Errata sheet LPC18S50, LPC18S30, LPC18S10

Rev. 1.6 — 20 April 2016

Errata sheet

3.7 ISP.2

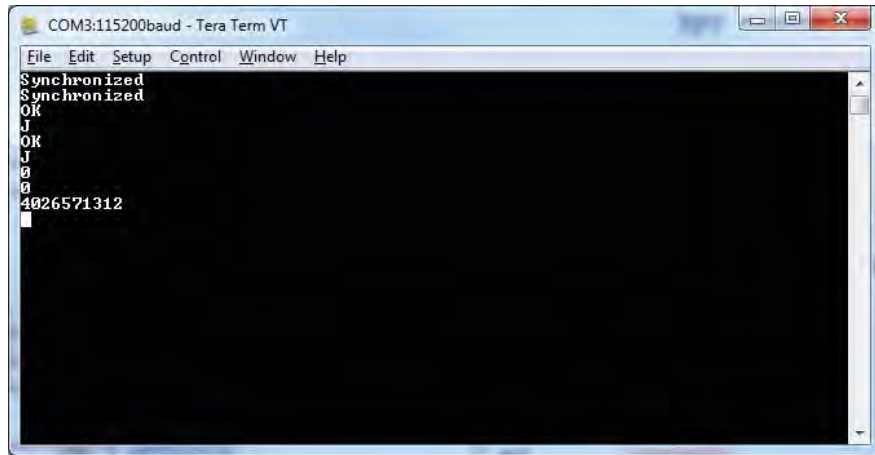
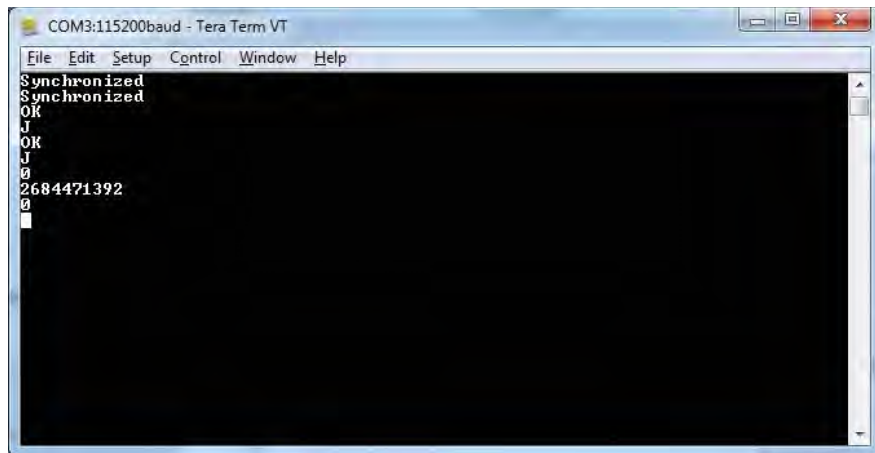
The 'J' command in ISP mode should return an error code, followed by an ASCII string representation of the part ID, followed by a 0. However what is actually returned is the error code, followed by a 0, followed by an ASCII string representation of the part ID. The problem is the last two items returned are swapped.

Incorrect example:

Correct example:

There is no work-around for this problem.

3.10 OTP.2

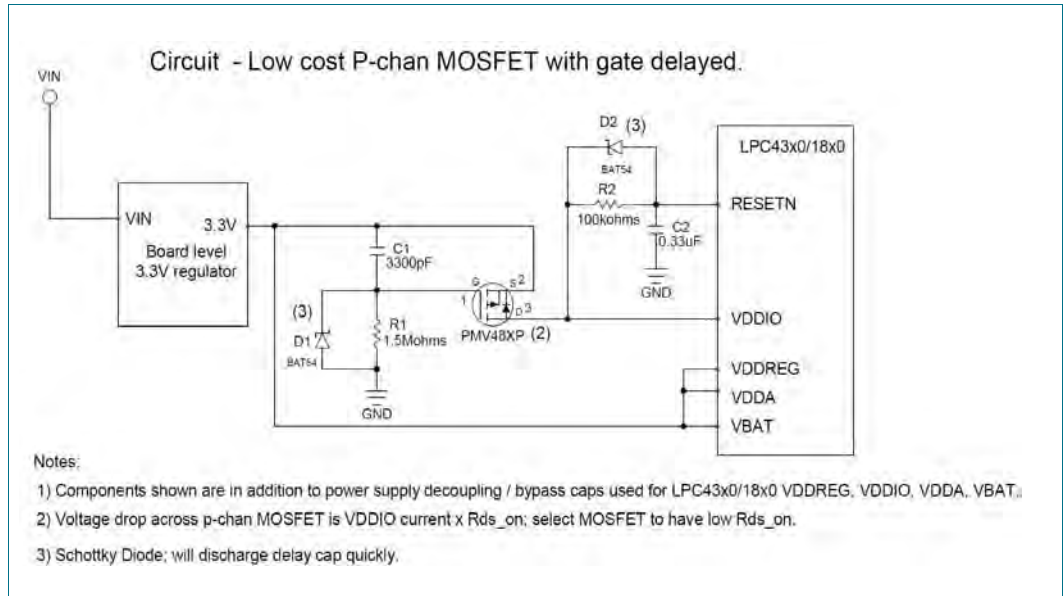
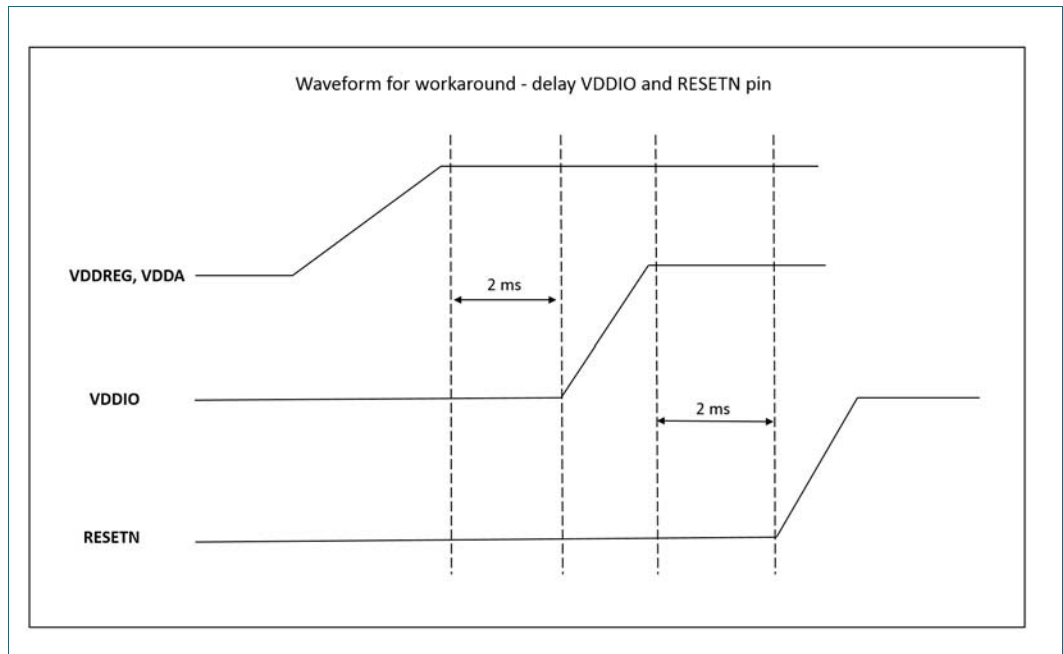
On all packages, repeated power cycling of the device may cause erroneous programming of the OTP banks. During ramp-up, the VDDREG supply voltage does not have enough time to settle and initialize the OTP controller before valid programming voltage is reached on the VPP pin. This may cause accidental programming of the OTP banks. Accidental programming of the OTP banks does not occur during Power-down of the supply voltage.

The following circuit diagram is an example that shows the P-channel MOSFET with the gate delayed and the R-C delay circuit connected to the RESETN pin.

The following diagram shows the waveform for the work-around.

- Do not tie VDDIO to VDDREG and VDDA pins. The power supplied to the VDDIO pin should be delayed by 2 ms after the power supply on the VDDREG and VDDA pins stabilizes at the operating voltage level. The signal to the RESETN pin must also be delayed by 2 ms after the power supply on the VDDIO pin stabilizes at the operating voltage level.

Fig 3. PMC wake-up keep-out area

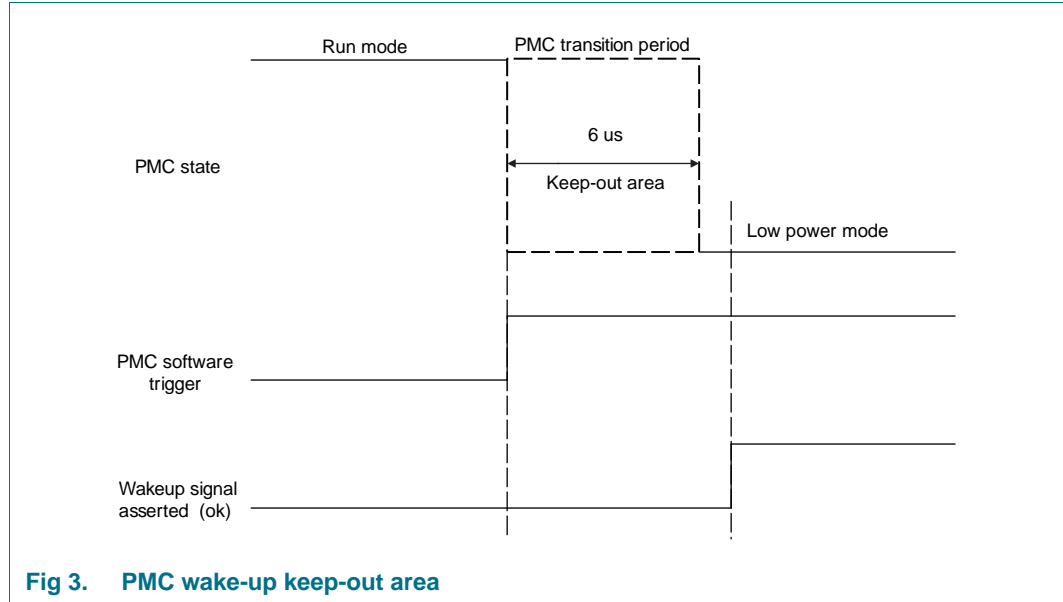
When the chip is in a transition from active to Deep Sleep, Power Down, or Deep Power Down, wake-up events are not captured and they will block further wake-up events from propagating. The time window for this transition is 6 μ s and is not affected by the chip clock speed. After a wake-up event is received during the PMC transition, the chip can only recover by using an external hardware reset or by cycling power.

Make sure that a wake-up signal is not received during the Deep Sleep, Power Down, or Deep Power Down transition period. An example circuit to work around this could include an external 6 μ s one shot which could be triggered via software using a GPIO line when entering Deep Sleep, Power Down, or Deep Power Down mode. The one-shot's output could be used to gate the wake-up signal(s) to prevent receiving a wake-up signal during the PMC transition period. Depending on the system design, it may also be needed to latch the wake-up signal(s) so that they will still be present after the one-shot's 6 μ s time-out.

Fig 4. Suggested USB0 to low-speed peripheral connections

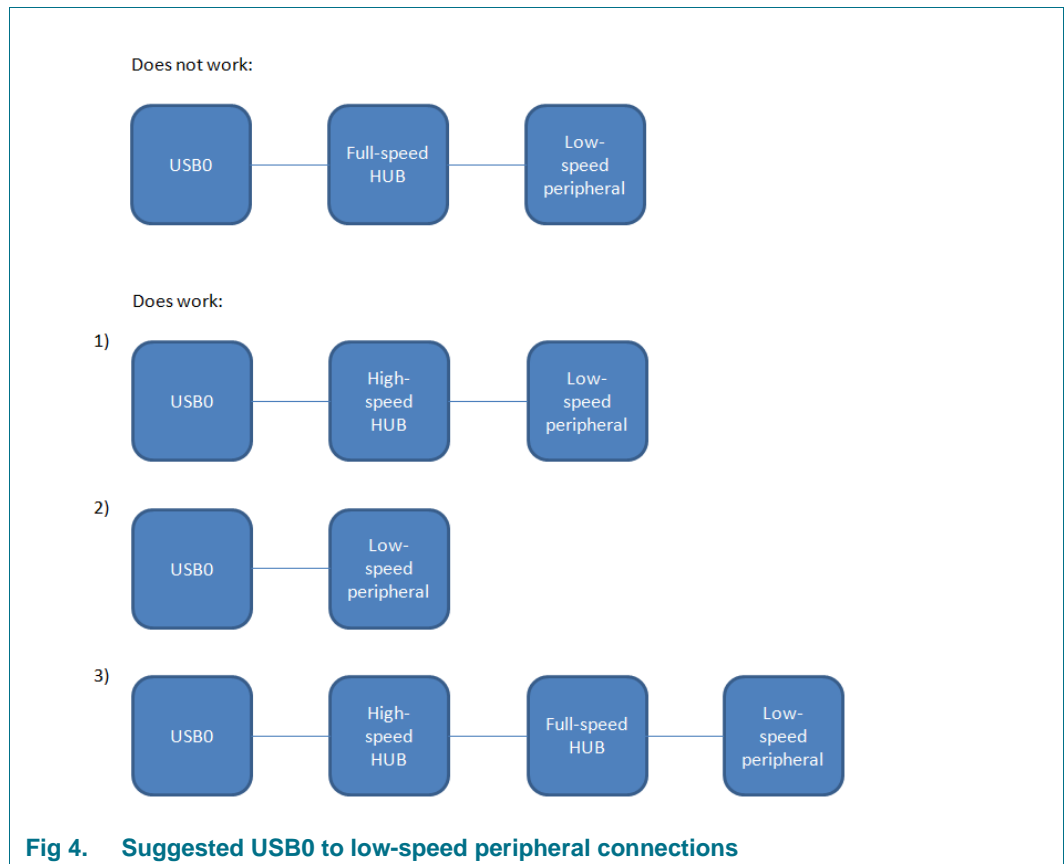
The USB controller called USB0 is unable to communicate with a low-speed USB peripheral in host mode when there is a full-speed hub directly connected to the USB0 port and a low-speed peripheral is connected in the tree somewhere below this full-speed hub. Only USB0 has this problem; the other USB controller, USB1 does not.

There is no work-around for this problem. It is suggested that the low-speed USB peripheral is either connected directly to USB0 or a high-speed hub is placed between that peripheral and USB0.
